RESIDENTIAL FLAT BUILDING DEVELOPMENT

17 (LOT 1 DP 973520), 19 (LOT 1 DP 972422), 21 (LOT 1 DP 972554) SHIRLEY ROAD, ROSEVILLE NSW 2069

DEVELOPMENT APPLICATION

Schedule of Changes (RFI)		
ITEM NO.	DESCRIPTION	DRAWING REFERENCE
PLANNING AND URBAN DESIGN		
ITEM 1.1	Ground Floor and Level 1 courtyards revised to balconies at building setback, and replaced with deep soil landscaping.	AR 103, AR 104

DRAWING TITLE
Level 5-6 (Typical) GA Plan

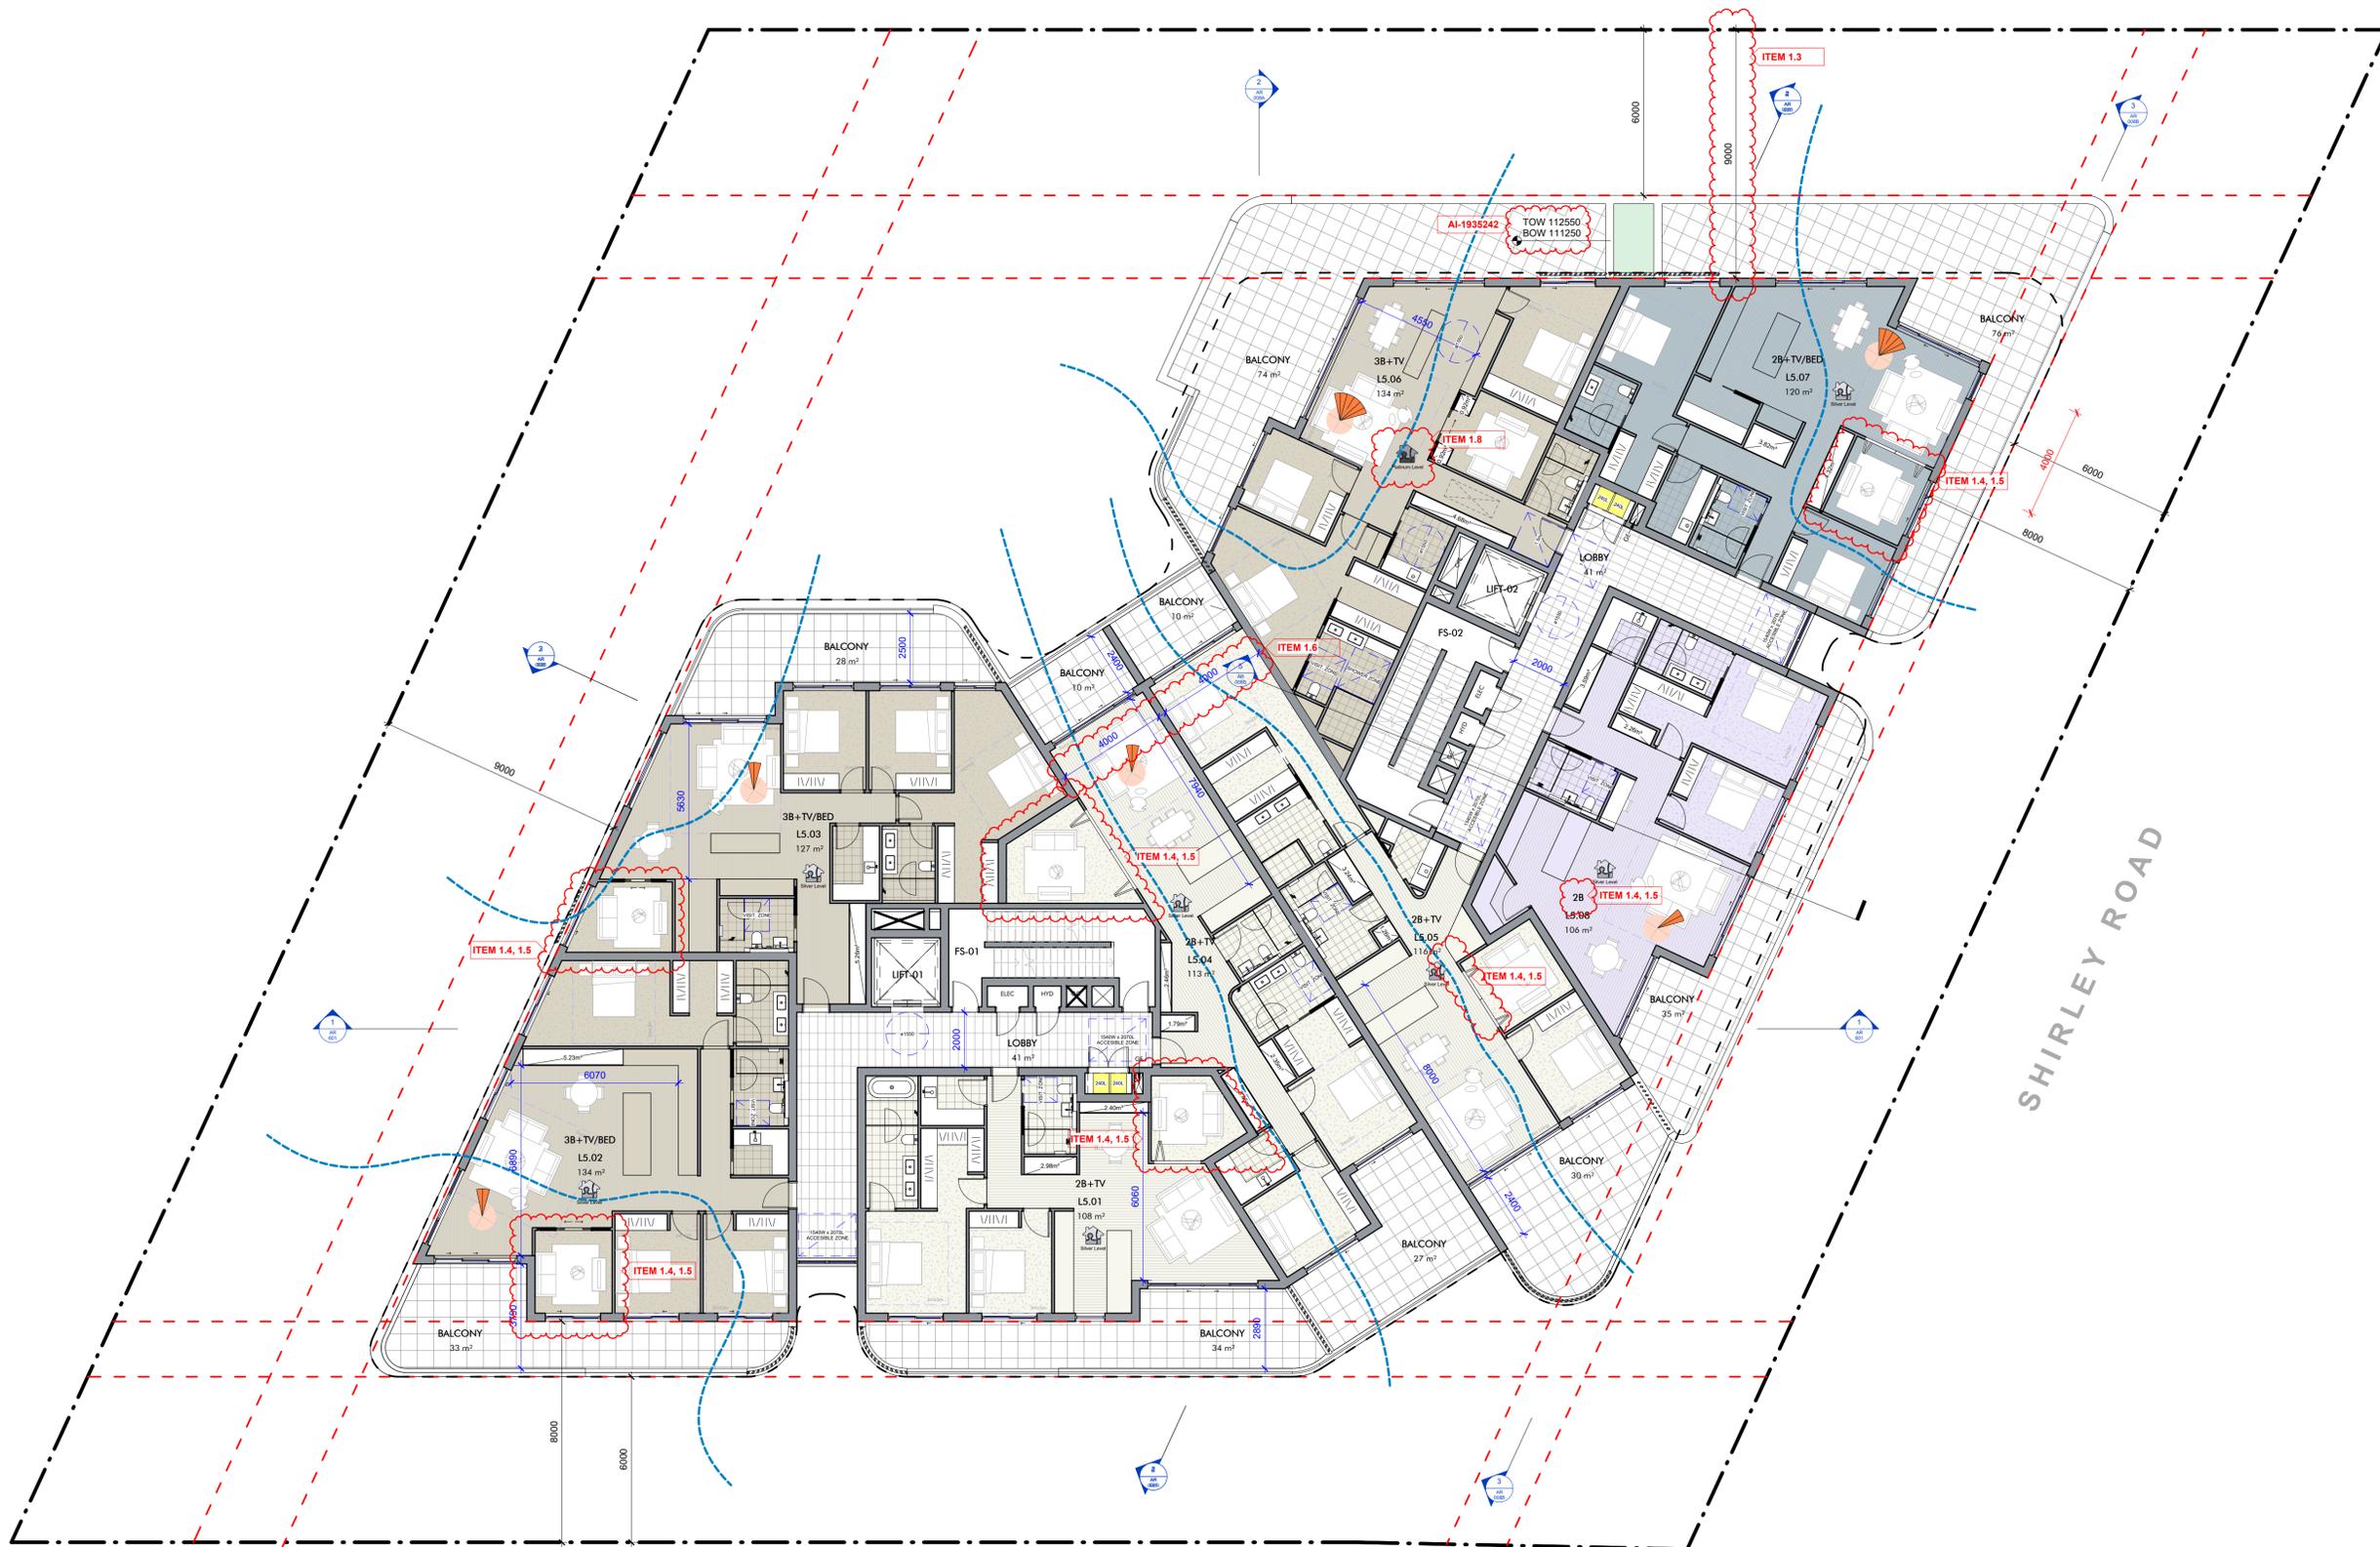
ITEM 1.2	Building levels amended to allow accessible street entry without stairs or platform lifts i.e. 1 in 40 maximum grade.	AR 103
ITEM 1.3	Levels above four storeys amended to maintain 9m setback from the site boundaries.	AR 105, AR 106, AR 107

ITEM 1.4, 1.5	Design revised to increase natural daylight and ventilation to TV rooms.	AR 104, AR 105, AR 106
ITEM 1.6	Dimensions added demonstrating 4m internal width per ADG 4D-3.	AR 104, AR 105, AR 106

ITEM 1.7	Affordable Units revised. Total area provided demonstrating at least 2% of GFA will be used for affordable housing.	AR 001, AR 007
ITEM 1.8	Total of nine (9) Platinum Level Livable units and car spaces provided to achieve 15% of total apartments.	AR 001, AR 100, AR 101, AR 102, AR 104, AR 106

ITEM 1.12	Storage walls adjacent to external shoring walls amended to mesh for maintenance.	AR 001, AR 100, AR 101, AR 102, AR 104, AR 106
ITEM 1.13	GFA Plans increased in scale, additional sheet added.	AR 007, AR 007A
LANDSCAPING

DRAWING TITLE
Building Elevations - North & East

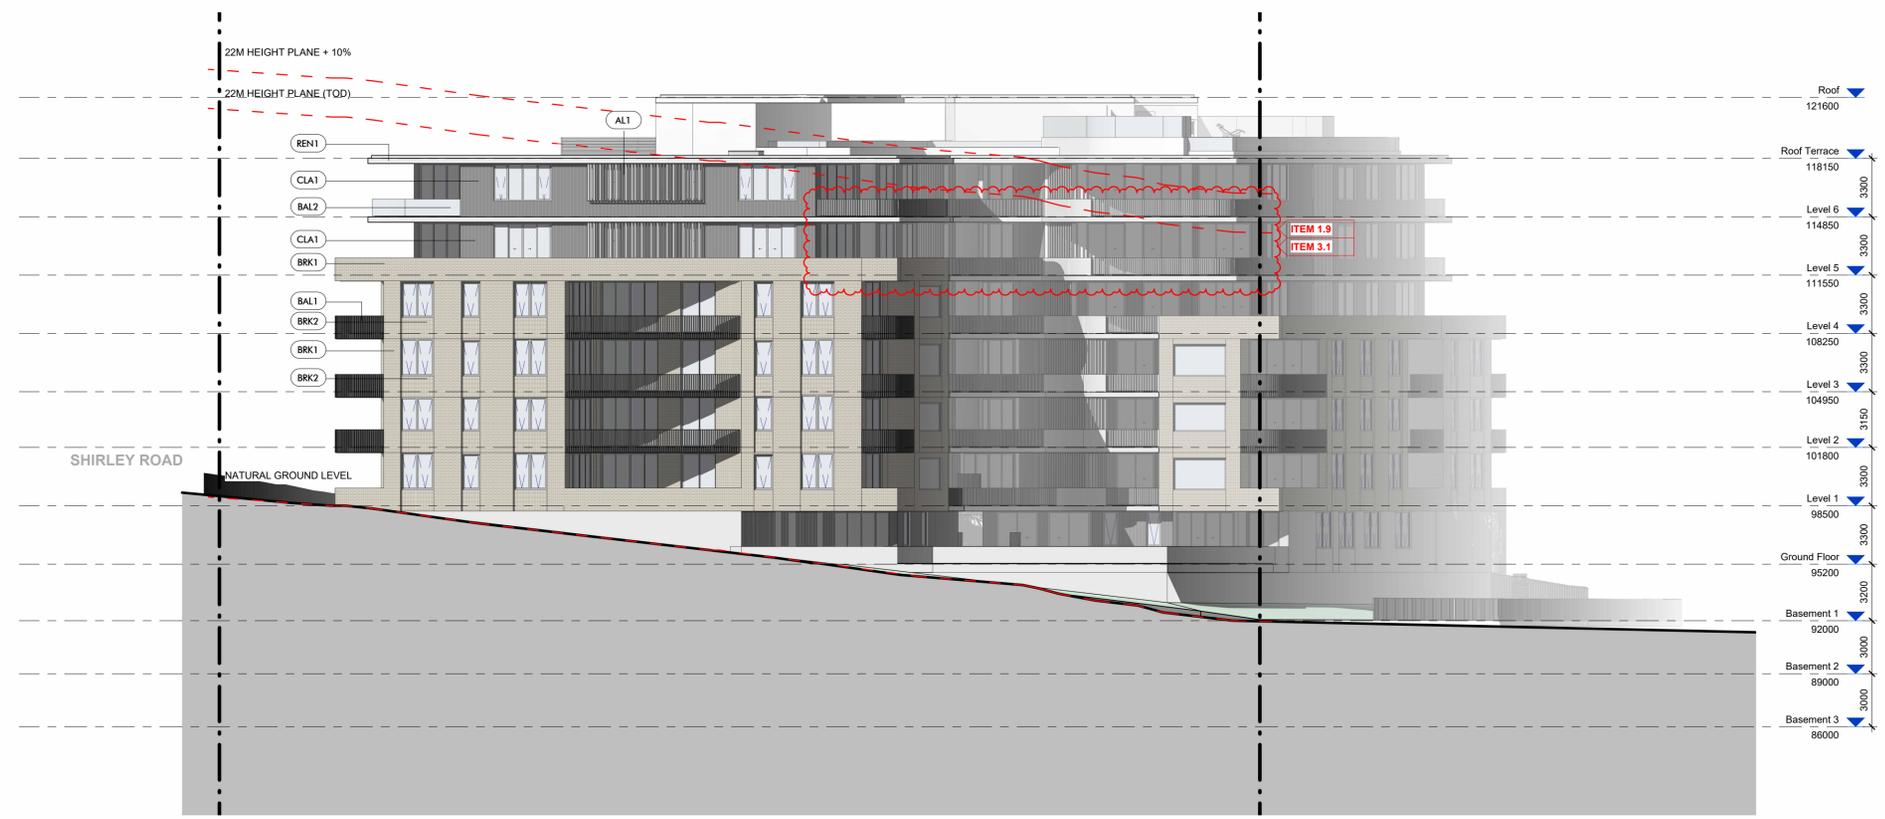
ITEM 1.9	Facade revised to reduce amount of glazed balustrades.	AR 400, AR 401
ITEM 1.10	Site analysis diagram updated to include tree canopy and topography.	AR 006

ITEM 3.1	Facade revised to reduce amount of glazed balustrades. Facade details amended to be more sympathetic to existing streetscape. Refer item 1.9.	AR 400, AR 401
ENGINEERING
